Consensus Committee Report: Initial Formal Action on Public Comments

March 15, 2019

Figure 613.6 Coefficient I_e relative to geographic location

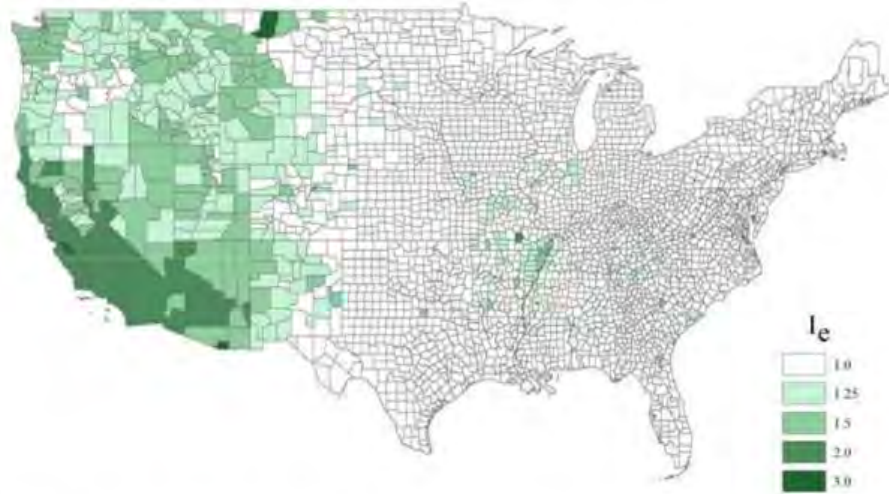
613.x Enhanced resiliency to earthquakes. The strength and stiffness requirements of the 2018 IBC and IRC are exceeded in locations designated in figure 613.6 with coefficient $I_e > 1$.

<u>I_e</u>	<u>Percent Enhancement Above 2018 IBC and IRC Seismic Requirements</u>	<u>Points</u>
<u>1.25</u>	<u>25%</u>	<u>4</u>
<u>1.5</u>	<u>25%</u>	<u>3</u>
	<u>50%</u>	<u>6</u>
<u>2.0</u>	<u>25%</u>	<u>2</u>
	<u>50%</u>	<u>4</u>
	<u>100%</u>	<u>10</u>
<u>3.0</u>	<u>25%</u>	<u>1</u>
	<u>50%</u>	<u>3</u>
	<u>100%</u>	<u>7</u>
	<u>200%</u>	<u>15</u>
